Edwin I. Hatch Nuclear Plant  
Response to Request for Additional Information  
Relative to  
Request to Revise Technical Specifications:  
Quarterly Surveillance Extension

Edwin I. Hatch Nuclear Plant  
Response to Request for Additional Information  
Technical Specifications Quarterly Surveillance Extension Request

FIGURE E-1  
 TYPICAL TRM INSTRUMENTATION CROSS-REFERENCE TABLE

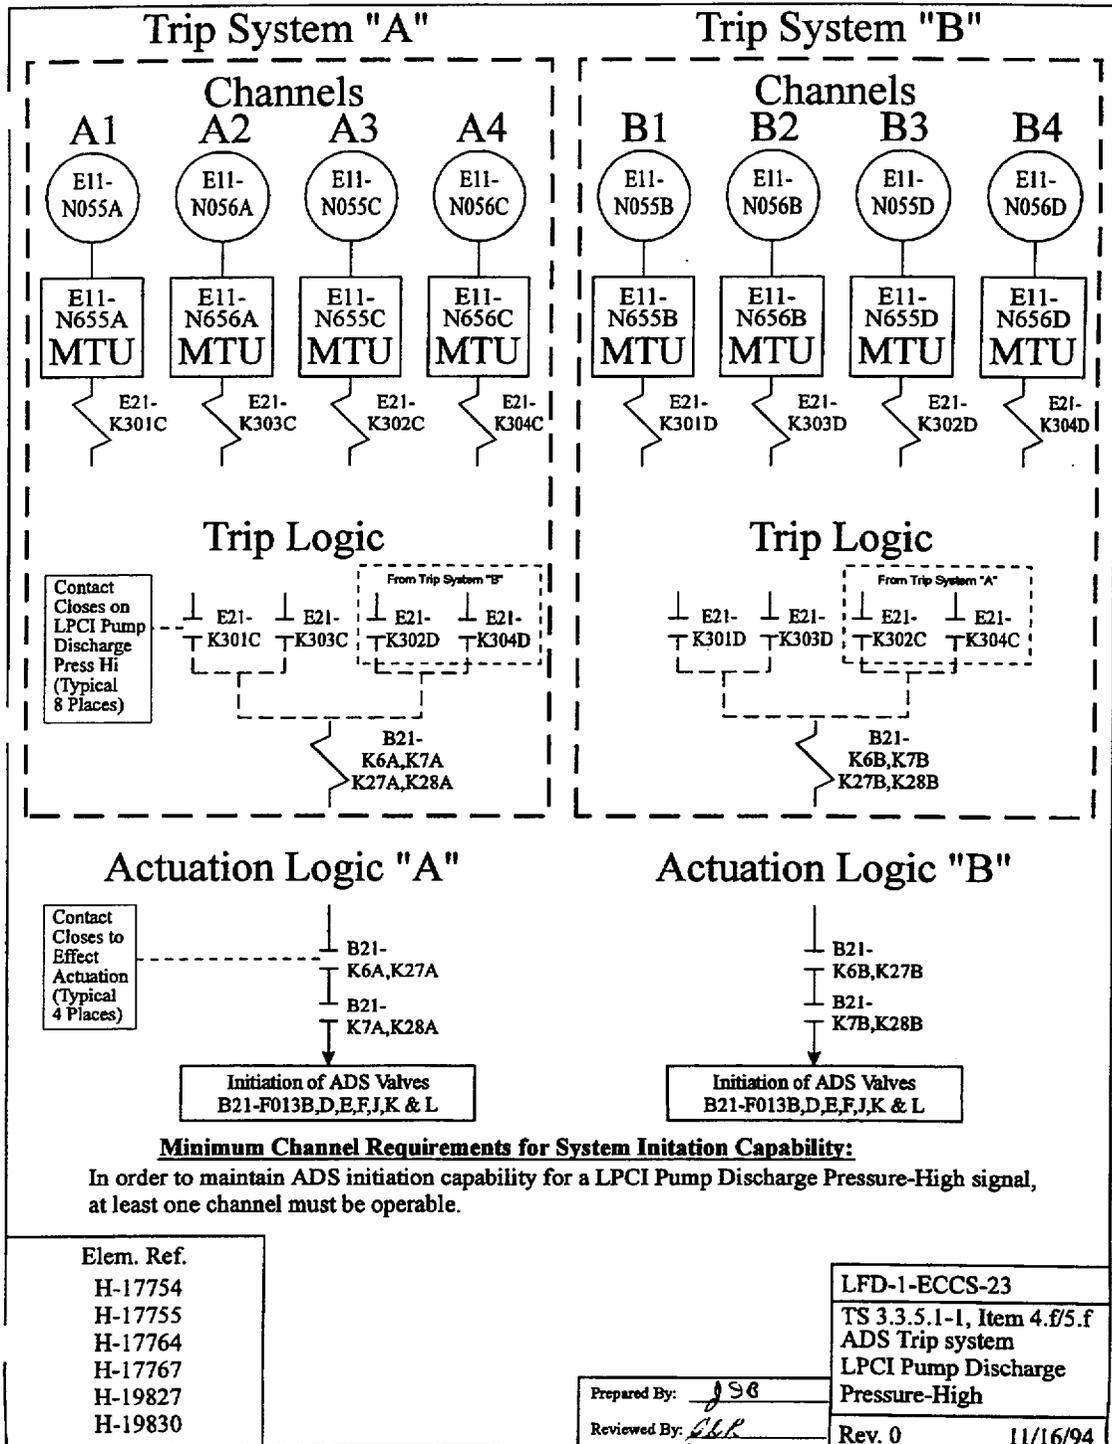
**Provide list of equipment and test boundaries included in a channel functional test .**

Since the NRR reviewers are not on distribution for the TRMs, the following response is provided for information only in support of the NRR's request. A page from TRM Table T10.1-1, which lists instrumentation associated with various Specifications, and LFD-1-ECCS-23, which shows the defined boundaries for a specific instrumentation loop, are provided as Figures E-1 and E-2, respectively.
